**Attachment
Review of Agency Planning Application**

City File: CDTP22-00045

Subject: **Geologic Peer Review / 30-Day Comments**
CDTP22-00045 / S. Weiss-Ishai (owner & appli.)
APN 188-150-010 / 201 Castle Hill Ranch Road
Walnut Creek Area, Contra Costa County
DMA Project 3053.22

TO: Syd Sotoodeh, Project Planner, Department of Conservation and Development
FROM: Larry Gossett, Senior Civil Engineer, Engineering Services Division
By: Joshua Laranang, Engineering Technician, Engineering Services Division
SUBJECT: **TREE PERMIT TP22-0045**
30-DAY COMMENTS – INCOMPLETE
(Weiss-Ishai/Castle Hill Ranch Road/Walnut Creek/ APN 188-150-010)
FILE: TP22-0045

Figure 1: CDTP22-00045 Vicinity Map with Alquist-Priolo Zones

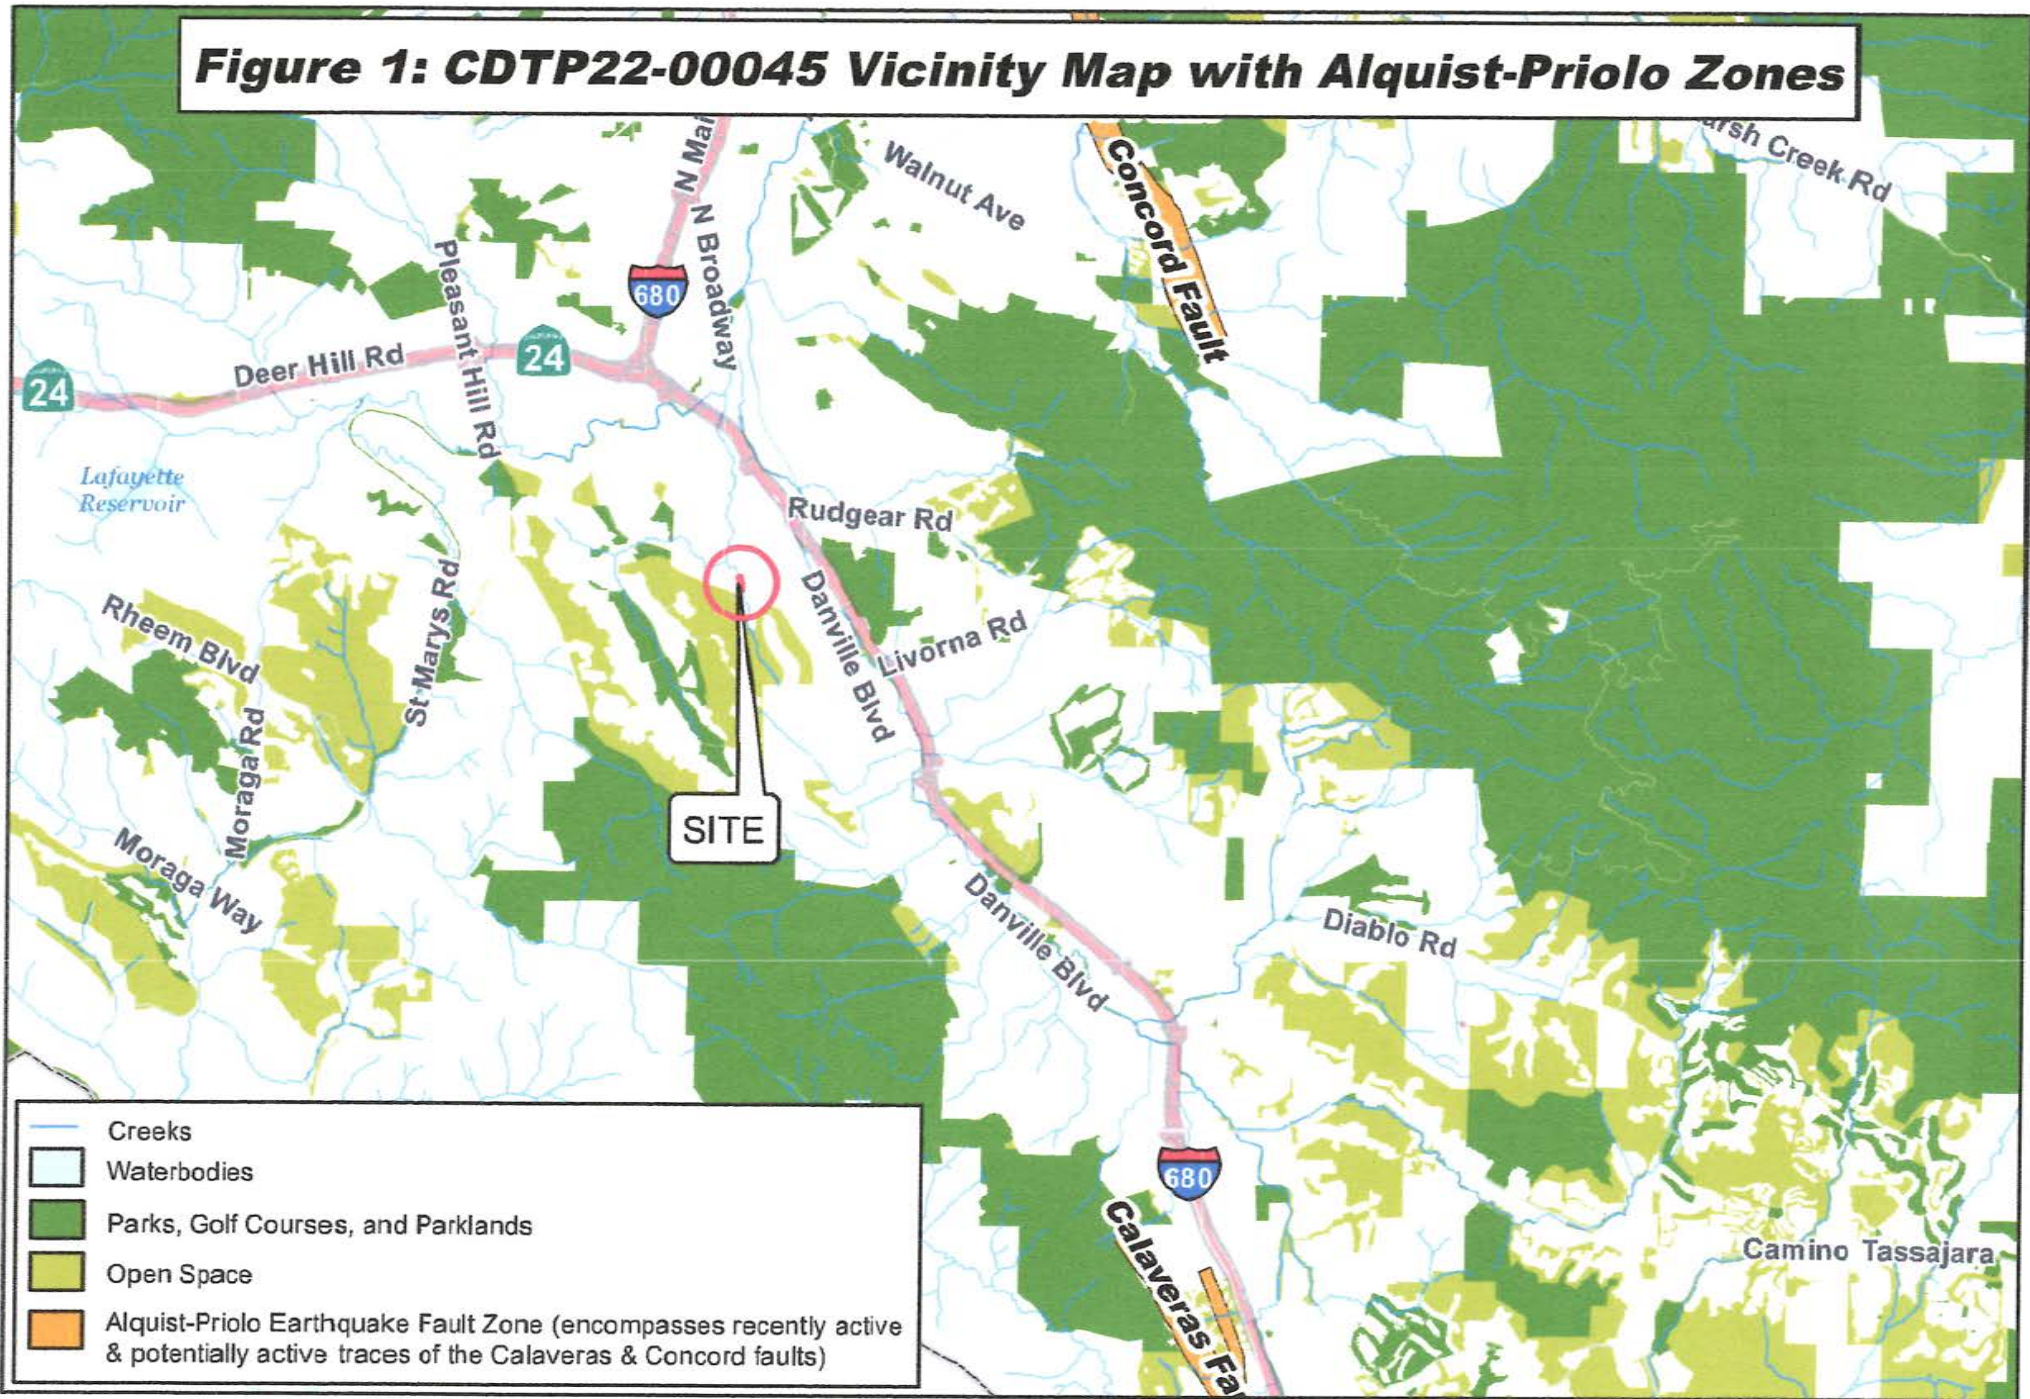
The project site is located in the southwest portion of the Walnut Creek area on the floor of a narrow update valley, with a tributary of Tice Creek passing along the property boundary. As noted previously, Figure 1 shows the A-P Zone that encompasses recently active and potentially active traces of the Concord and Calaveras fault. Other active faults in the East Bay area include Greenville and Hayward faults, which pass more than 6 miles to the east and southwest of the site, respectively. According to the State, recently active and potentially active traces of the active faults may be present anywhere in the A-P Zones. The location of surface rupture generally can be assumed to be along an active major fault trace. The site is not within the A-P Zone. Therefore, the probability of the project site experiencing surface rupture can be considered very low.

Figure 2: CDTP22-00045 USGS Geologic Map

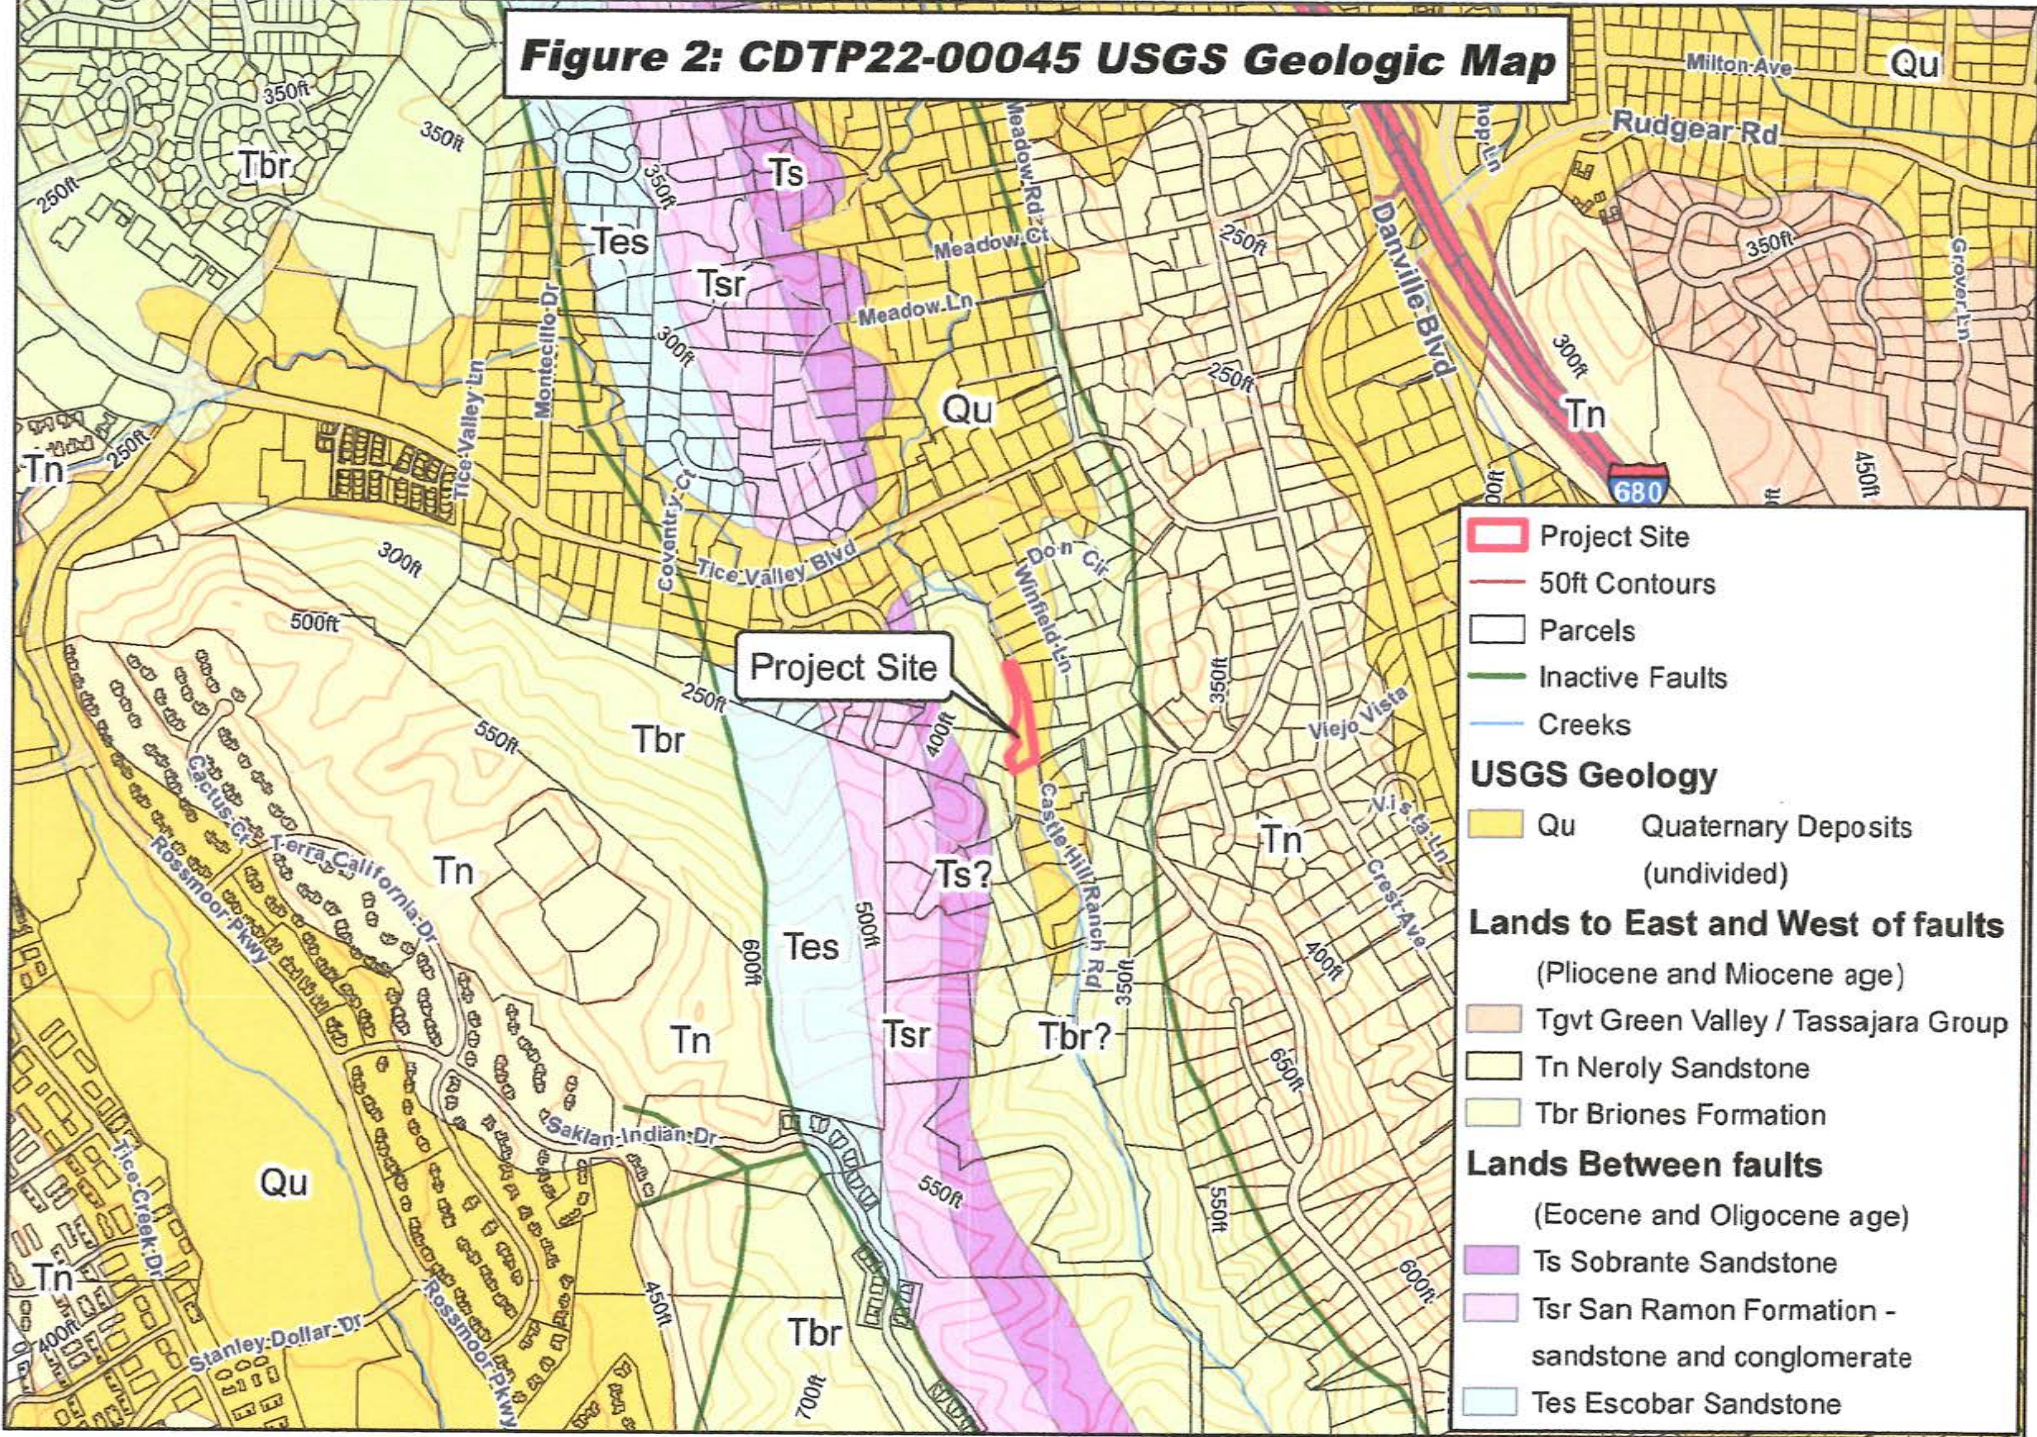
In 1994 the USGS issued a digitized, color bedrock geology map of Contra Costa County.³ Figure 2 shows the site and surrounding area at a scale of 1 in.=1,000 ft., with the boundaries of the site represented by a solid red line. According to this map the project site is underlain by surficial deposits (Qu). Outcropping at/ near the west boundary of the site are marine sedimentary rocks of Miocene age. No faults bisect the site, but inactive bedrock faults are shown on the USGS map (each fault is represented by a solid green line in Figure 2). The fault trace mapped nearest the site trends generally to the north-northwest and passes approximately 600 ft. east of the site. Its location corresponds to the inferred location of the ancestral trace of the Calaveras fault in the Walnut Creek area.

During preparation of the 1994 USGS map, its authors were able to access unpublished data of petroleum exploration firms, including Chevron. This deep subsurface data allowed the tracing of a throughgoing fault from the vicinity of the I-680 / State Route 24 interchange to the north. However, the petroleum data is not useful in evaluating the Quaternary displacement history of this buried fault.

Figure 3: CDTP22-00045 USGS Quaternary Map

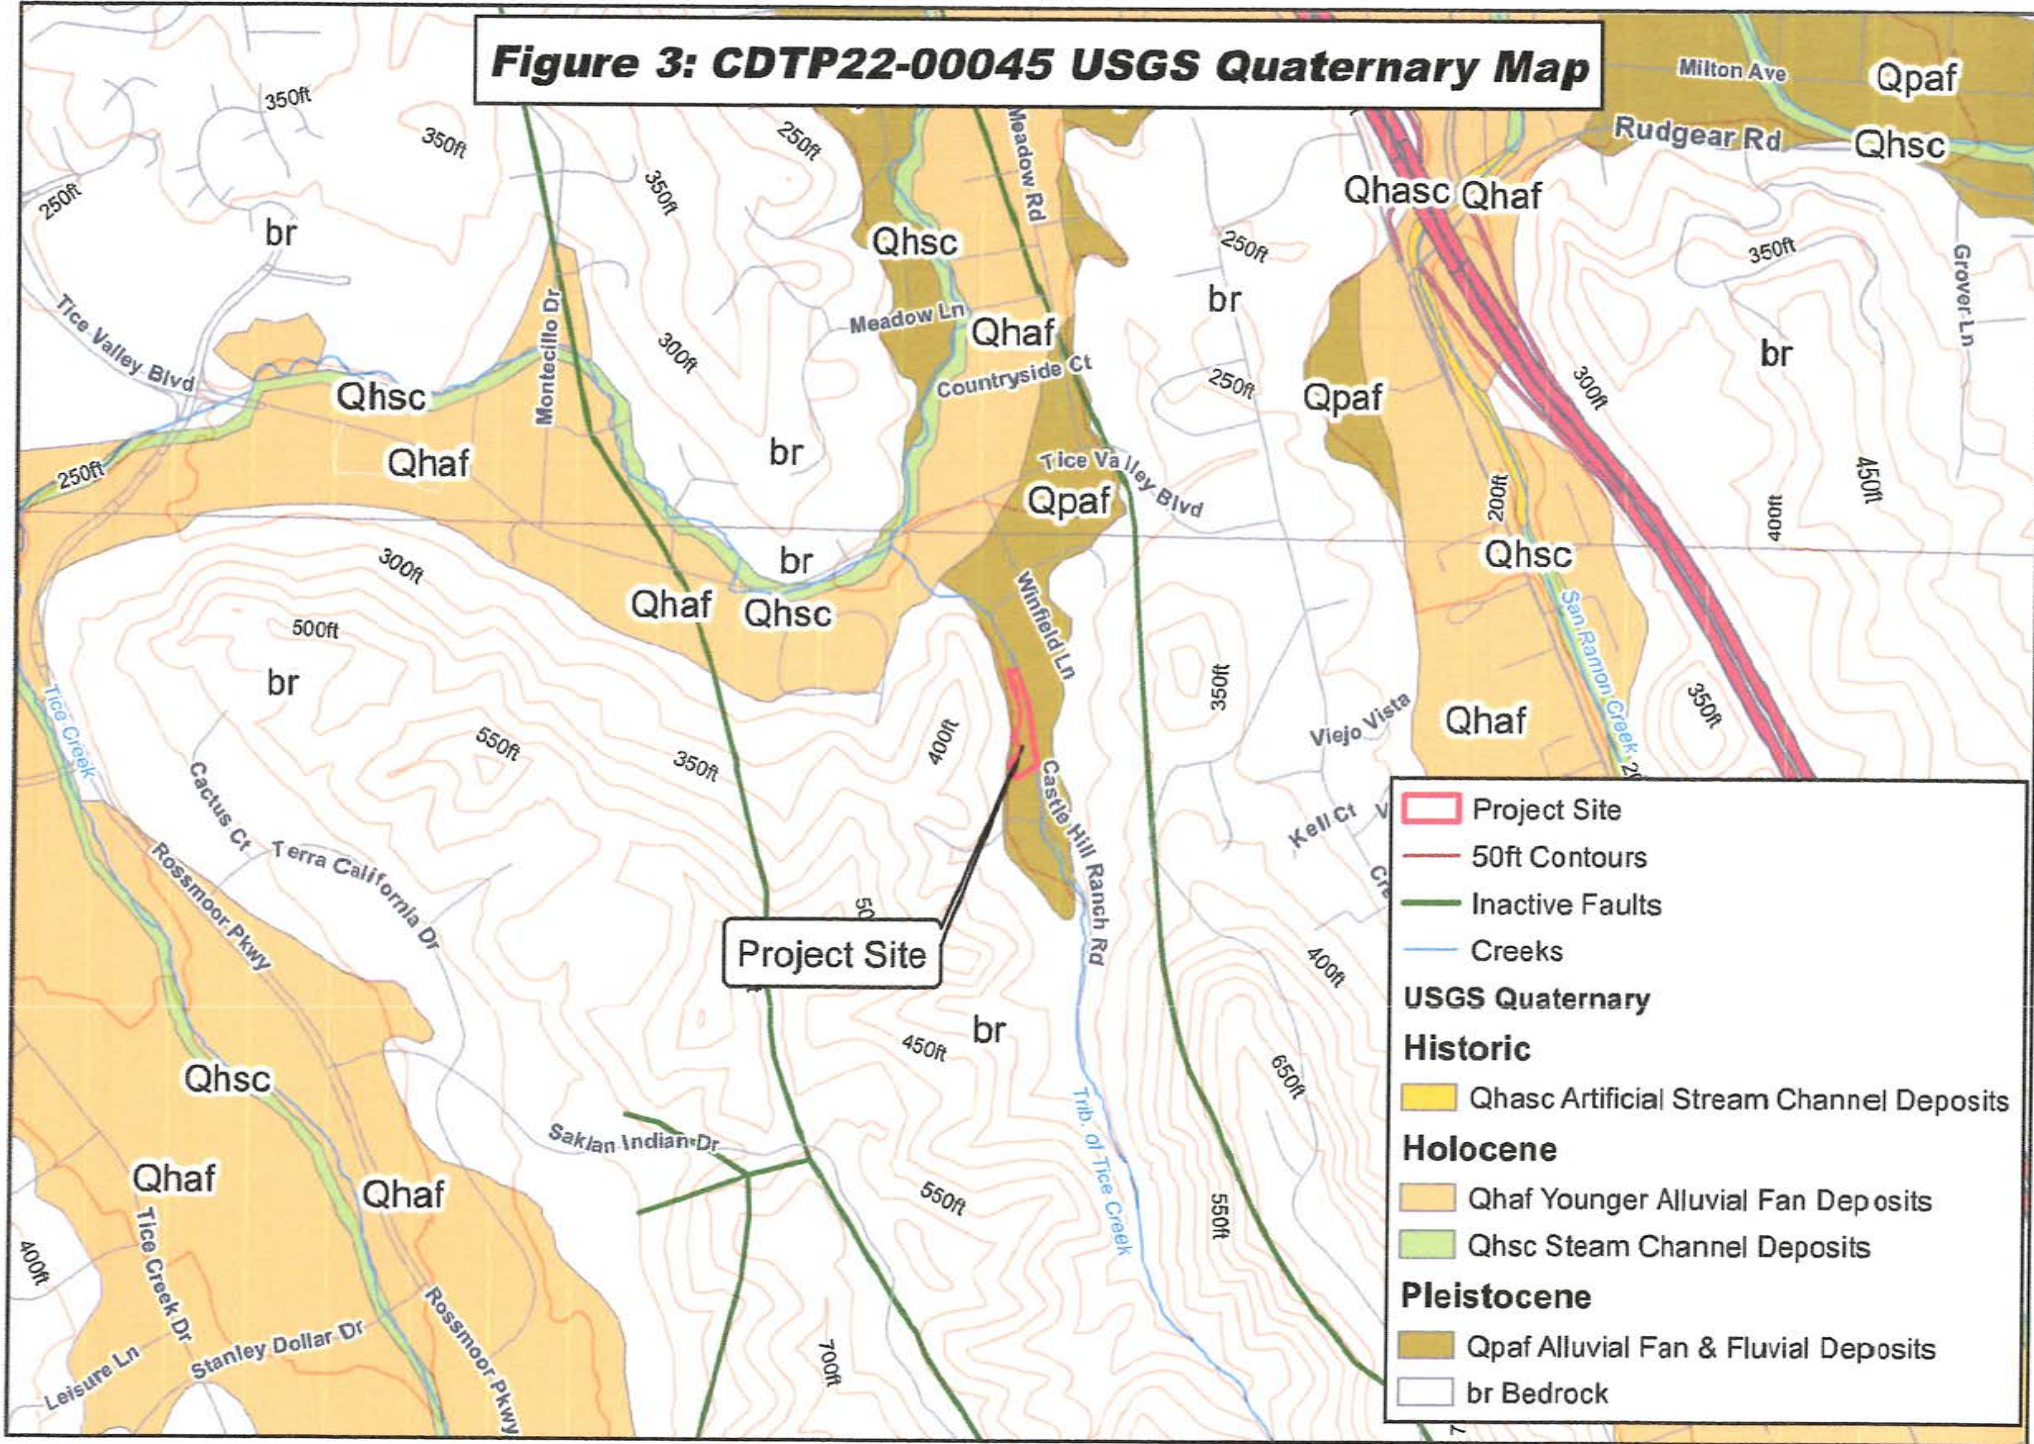
The most recent map of Quaternary deposits is mapping of the USGS.⁴ According to this map, the site is within an area of alluvial fan and fluvial deposits of Pleistocene age (see Figure 3). Other surficial deposits mapped in this area include both alluvial fan and fluvial deposits of Holocene age (Qhaf); historic stream channel deposits of Tice and San Ramon creeks (Qhsc); and artificial stream channel (Qhasc). The Pleistocene Epoch began 2.6 million years before present and ended approximately 11,000 years before present. Table 1 presents a description of these surficial deposits.
